Addendum A Alteration Approval Form

Re Addition & Alteration for flat no 301 BRCV

Details of Additions & Alterations

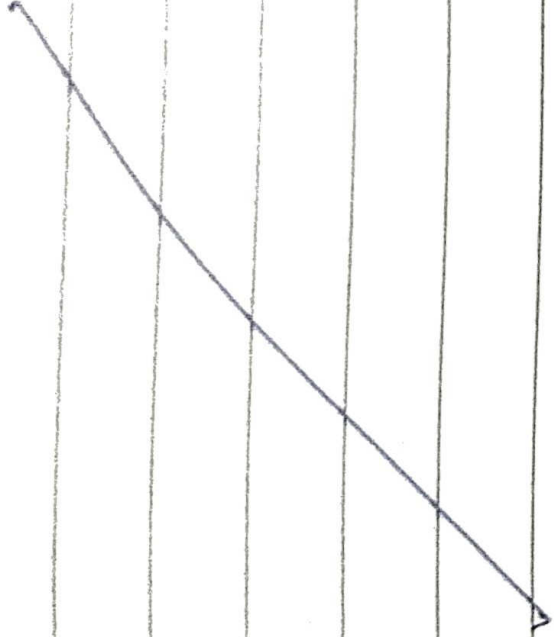
Changes in electrical points (mark on plan)

1) Geyser point should be moved to wall, Left corner.

2) 16 amp socket 2 nos in Kitchen, in string and one 16 amp socket 1 no's near TV point

3) Geyser point switch board should move right & left

4) Only plug point should be there in bathroom

on or off button should be outside of bathroom.

Choice of Bathroom tiles, CP fittings & Sanitary ware:

1) Geyser point should be moved a side | 16 amp
in both bathrooms. ✓

2) In both bathrooms Luma Series only plane (total)

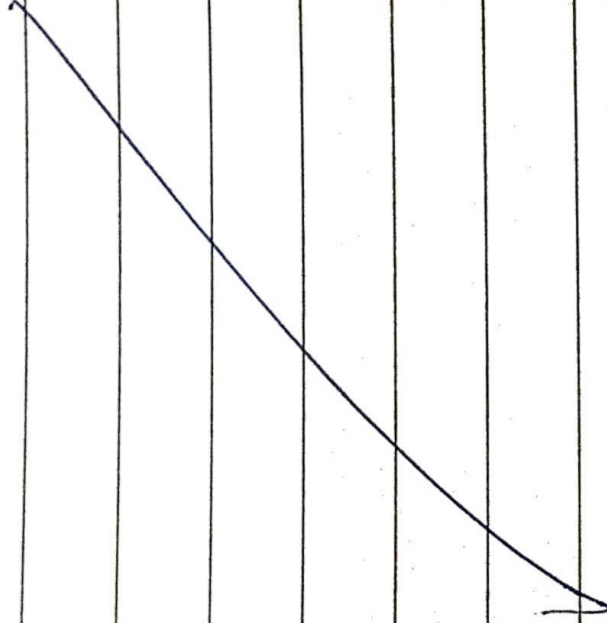
Changes in kitchen platform: (mark on plan)

1) In kitchen Beeslab

Other Changes:

- 1) master bathroom reverse opening of doors
- 2) In Utility Ventilator should come down.
